Access Compliance Report

Public Rights-of-Way

(Curb Ramps)

Intersection ID: 42736	Main Street: CONNELL_GREEN_DR	Cross Street: CALDWELL_FOREST_DR	Location: NE
ADA ID: C0D980E2D720	Ramp Type: BlendTrans1	Initial Pass/Fail: Pass	Overall Compliance: No
Severity Score: 10			
Codes/Mitigation Info/Possible Solution		Field Measurements/Component Compliance

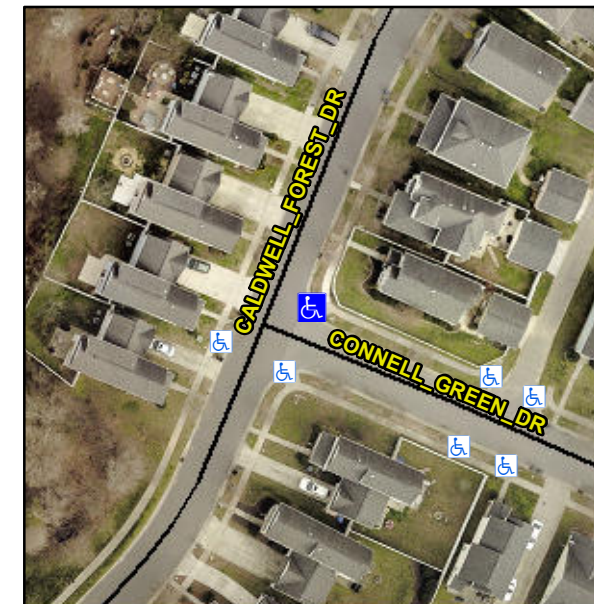
Remove & Replace Curb Ramp With Two New Directional Ramps or Equivalent.

Not Found, R304.2.1, R304.5.3, R305
